Annex 5: HW change description v1.2 to Test Report 20-1-0017102T02a-A5

Hardware change description
SICK LOCU1xx – UWB TAG

v1r3 -> v1r3.1 change description

Details for changes of LOCU Battery Basic/Advanced bottom layer:

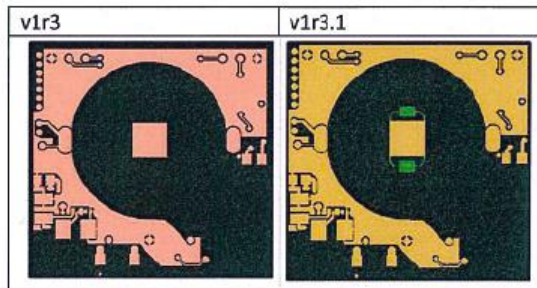
1. Battery holder: Pad adjustment of negative battery contact- milled grooves for battery holder are shifted in v1r3.1 comparing to v1r3. The pitch of grooves is increased by 0,45 mm.

- red mark - v1r3
- green mark - v1r3.1
